Authors' Reply

Reply to Reviewer #1

A cross-scale study for compound flooding processes during Hurricane Florence

Fig. 14: Simulated HWMs from the sensitivity run “no_NWM_precipOcean”, i.e., without the freshwater inputs from NWM or precipitation. Note the underpredictions in the watershed and worse model skill compared with “baseline” (Fig. 11).

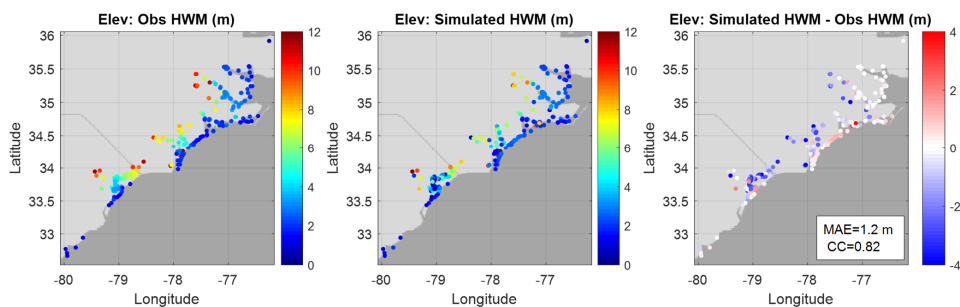
Please see comments on Figure 11.

Fig. 14’s main purpose is to show the adverse effect of excluding NWM and precipitation. Fig.14 shows more large errors (under-prediction, blue) than in Fig. 11 (baseline), because Fig.14’s has no stream flow from NWM or direct precipitation.

“Not surprisingly, without rivers and precipitation, watershed is mostly dry as the storm surge cannot propagate over steep terrains (Fig. 12). As a result, the predicted HWMs are biased too low (Fig. 14) as the steep topography quickly damped out any surges brought in by the ocean. *This leads to systematically underpredictions in the watershed and a 64% increase in MAE compared to the baseline (Fig. 11). ... Note that there is no apparent deterioration of model skill on the near-shore HWMs, because those locations are predominately affected by oceanic processes.*”
